TO: Jeff Weeder, Galloway and Company
FROM: Amber Wood Hicken, Planner I
DATE: 4/27/23
SUBJECT: Lincoln Professional Park L3 – Andy’s Custard, Site Plan, SP23-113
Review Comments 03

LINCOLN PROFESSIONAL PARK FILING NO.1 LOT 3

SITE PLAN DOCUMENTS

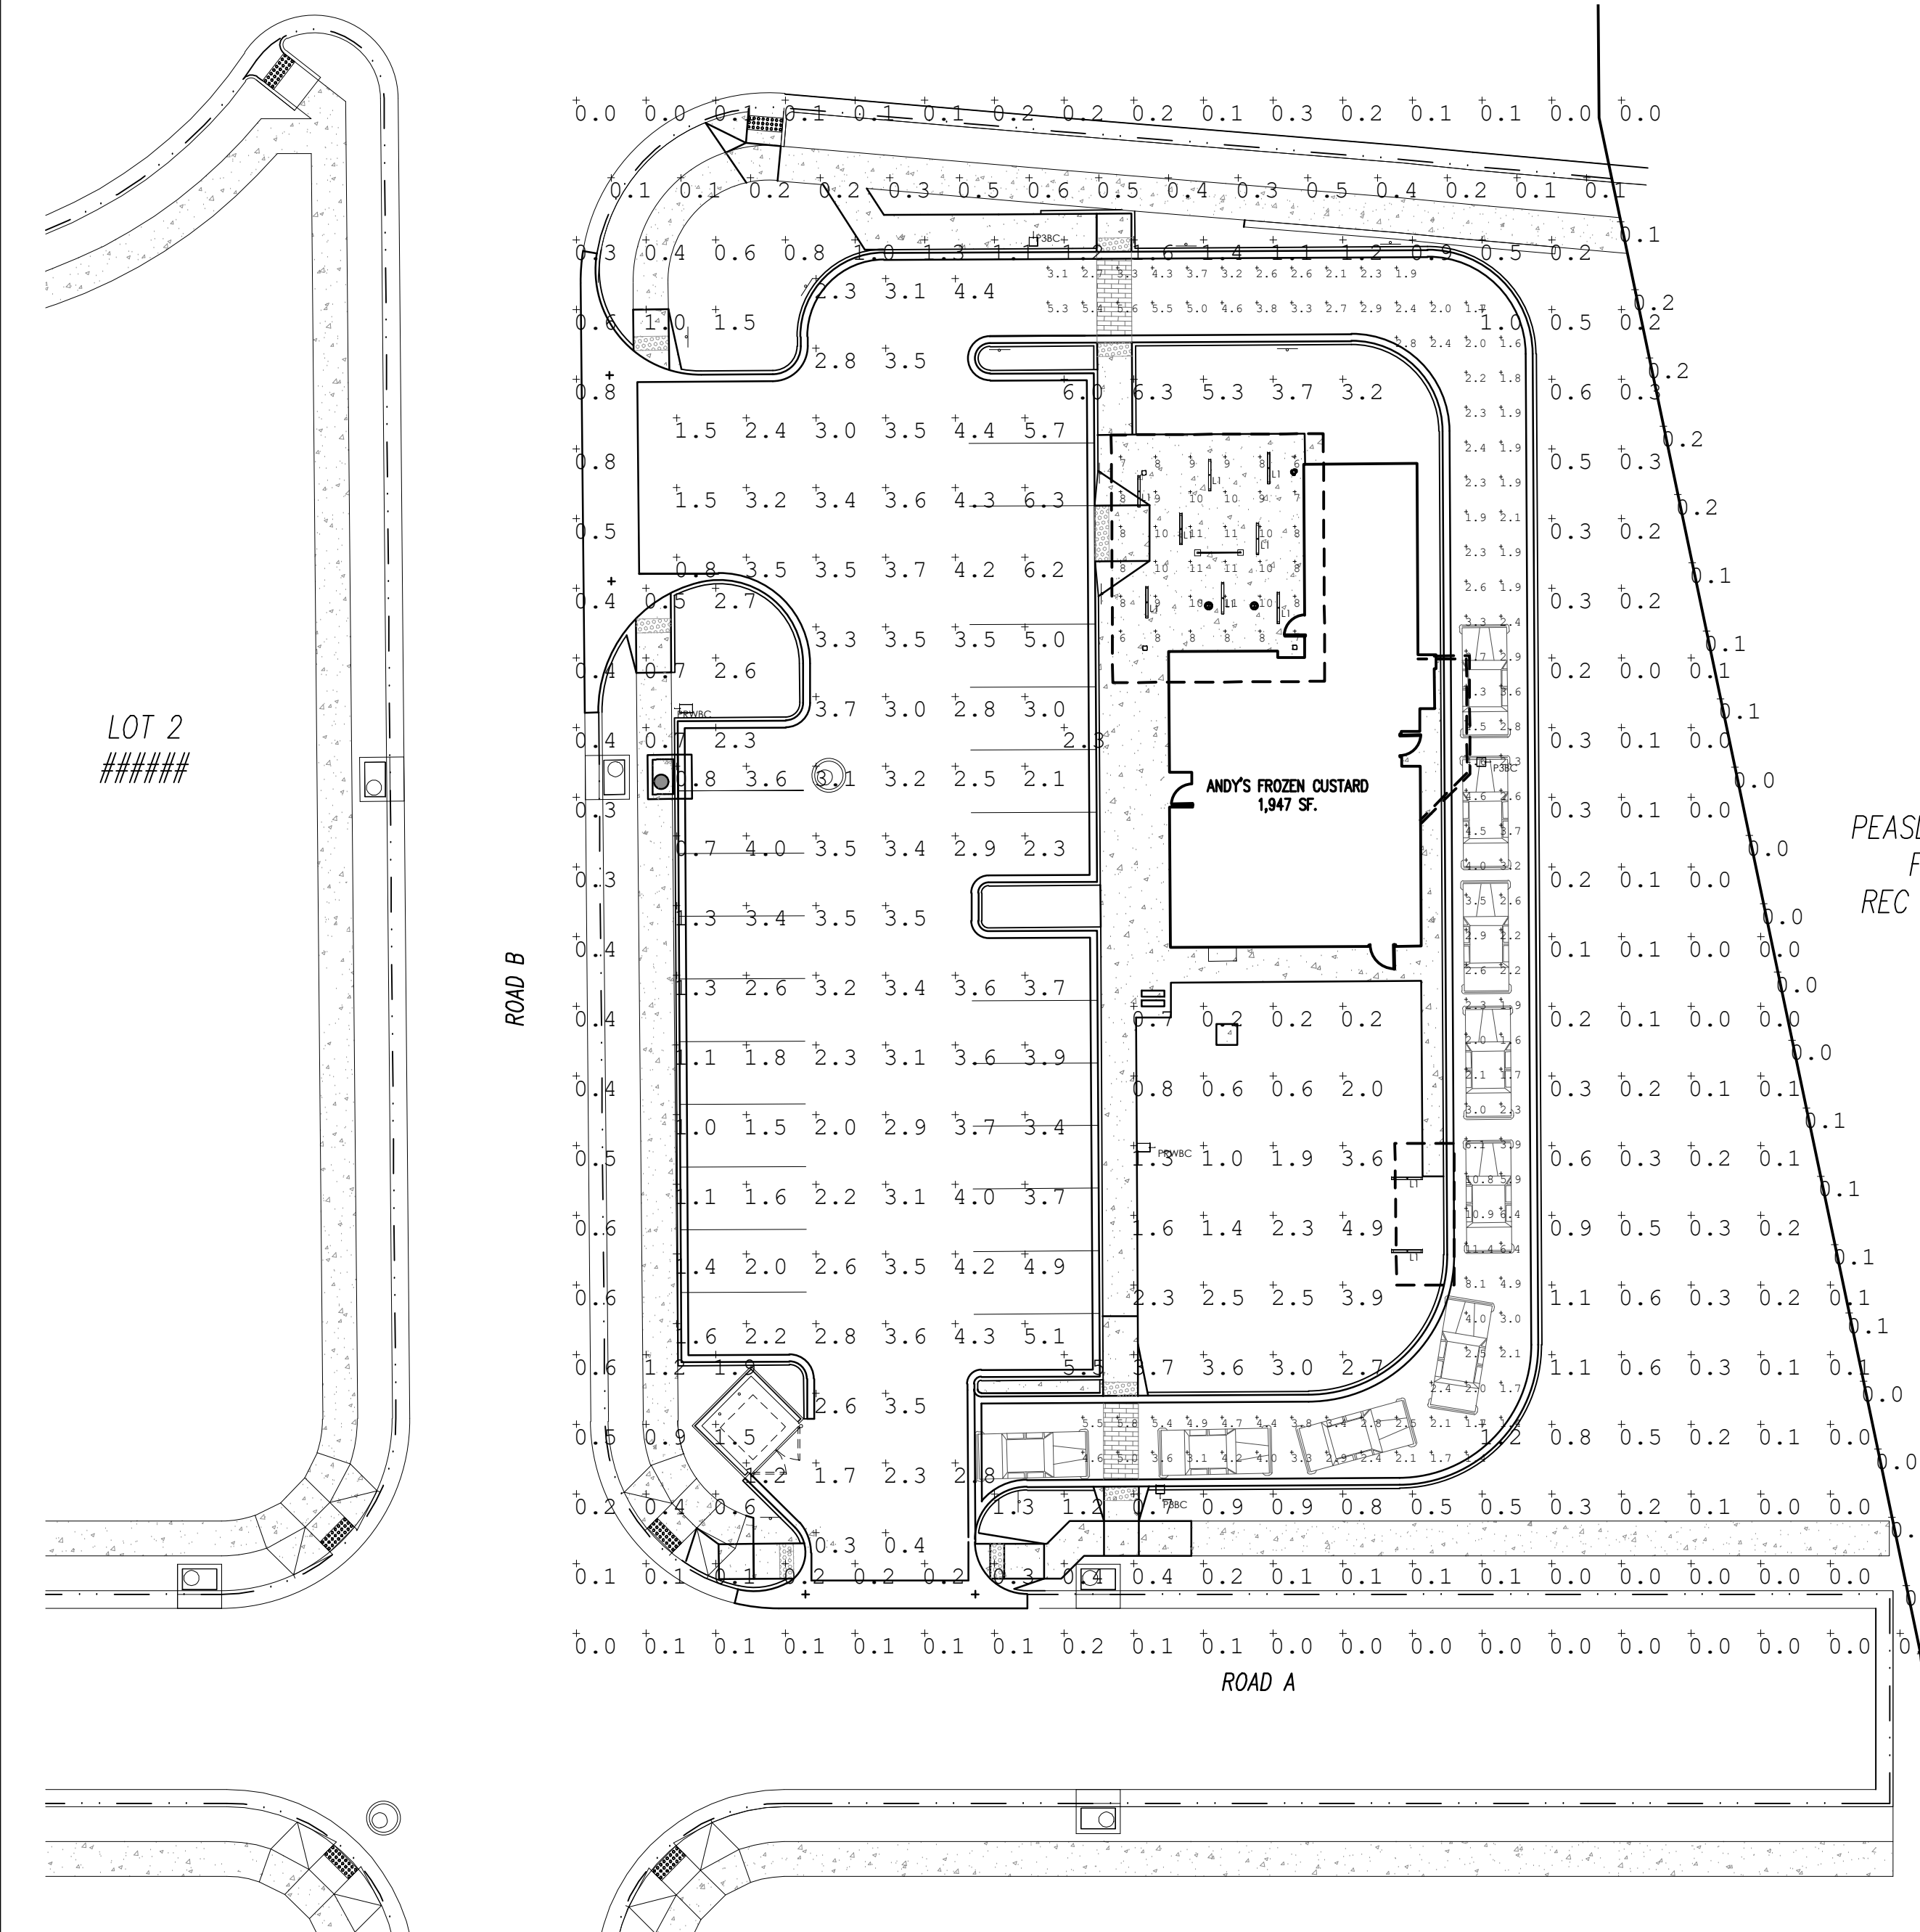
Please provide height and color of luminaires
Height and color added

Revised
average/min should be 3/1

Revised
Min/max should be 10/1

2
R002
BUILDING ELEVATION - NORTH FACE
1/4" = 1'-0"

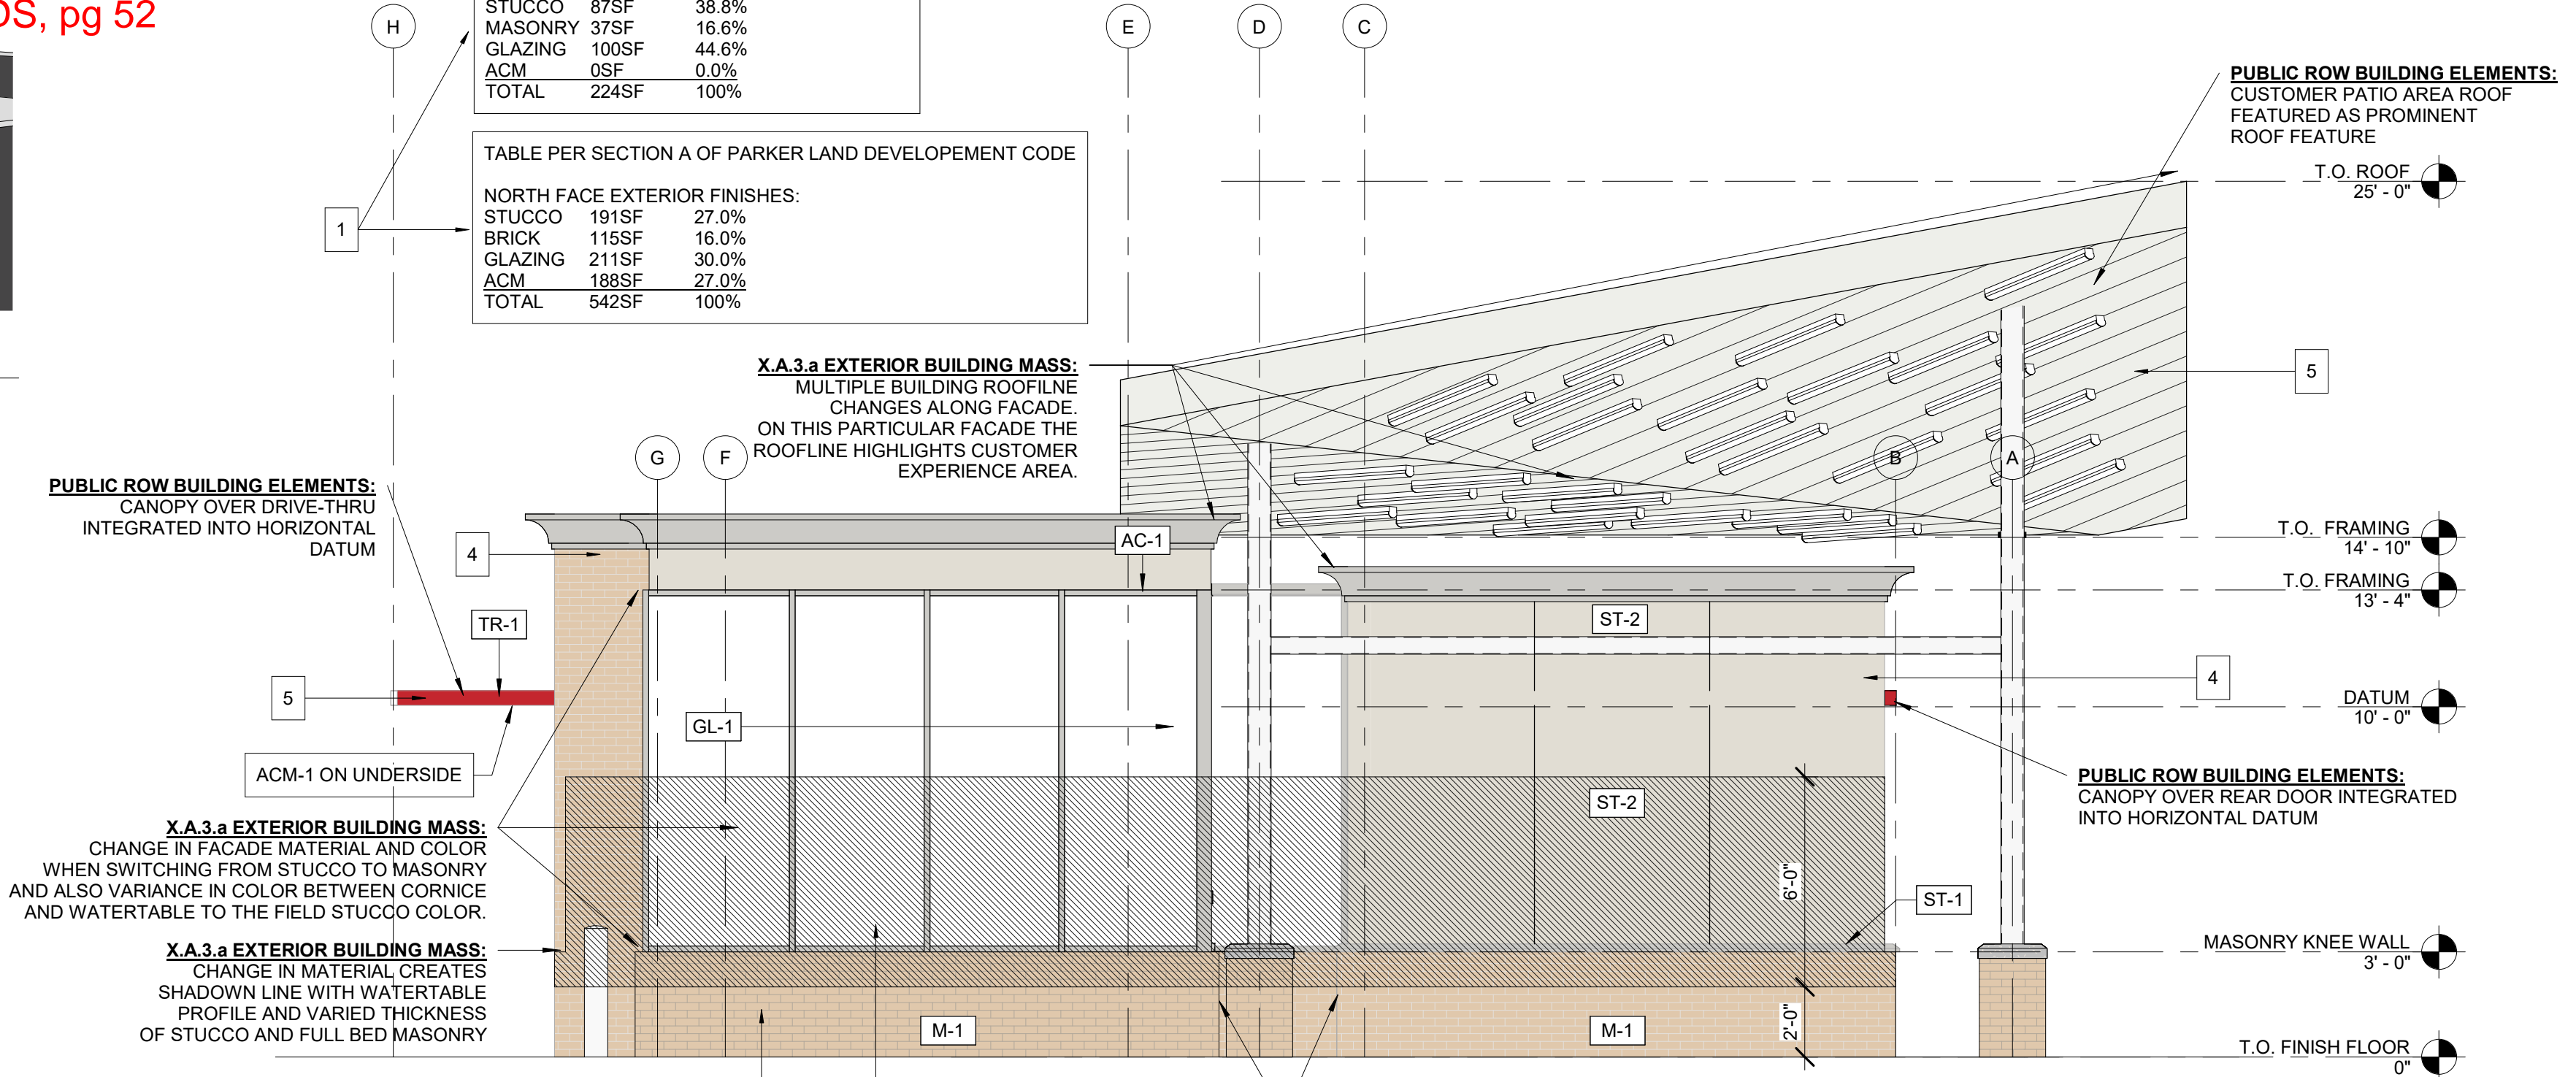
Please label this element - what it is, width, etc

Response: The element in question is the stucco control joint pattern. The stucco control joints have been enlarged from 1/2" to 1" reveals as part of the response to this comment.

1
R002
BUILDING ELEVATION - WEST FACE (ROAD B)
1/4" = 1'-0"

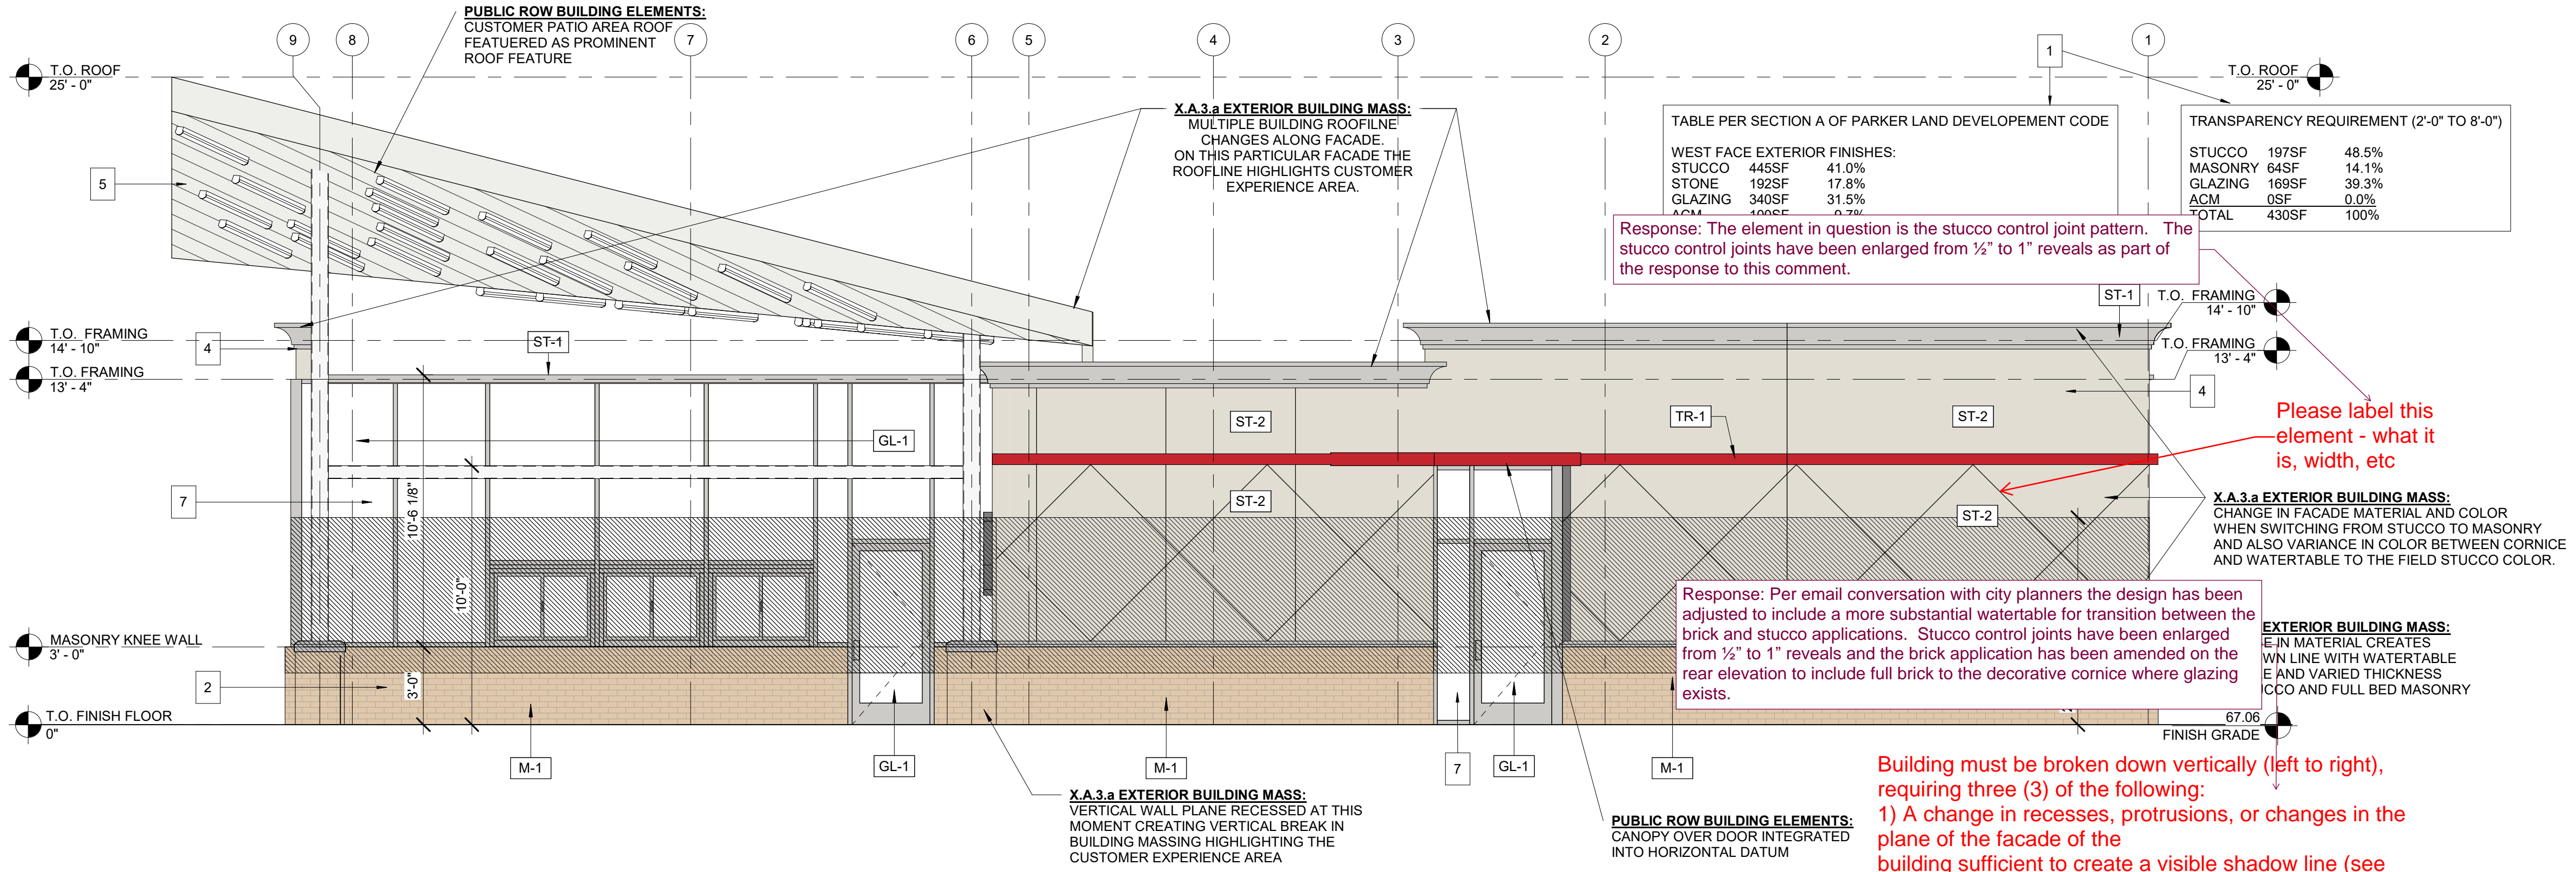
Building must be broken down horizontally (top to bottom) with a base, middle, and top. The middle should include:

- a) Visibly apparent material change
 - b) Step courses (horizontal banding)
 - c) Stepped, recesses or protrusions
- DDS, pg 52

Building must be broken down vertically (left to right), requiring three (3) of the following:

- 1) A change in recesses, protrusions, or changes in the plane of the facade of the building sufficient to create a visible shadow line (see figure 71).
- 2) A significant break in the eave line or roof form
- 3) A change in facade material or color

Response: Per email conversation with city planners the design has been adjusted to include a more substantial watertable for transition between the brick and stucco applications. Stucco control joints have been enlarged from 1/2" to 1" reveals and the brick application has been amended on the rear elevation to include full brick to the decorative cornice where glazing exists.
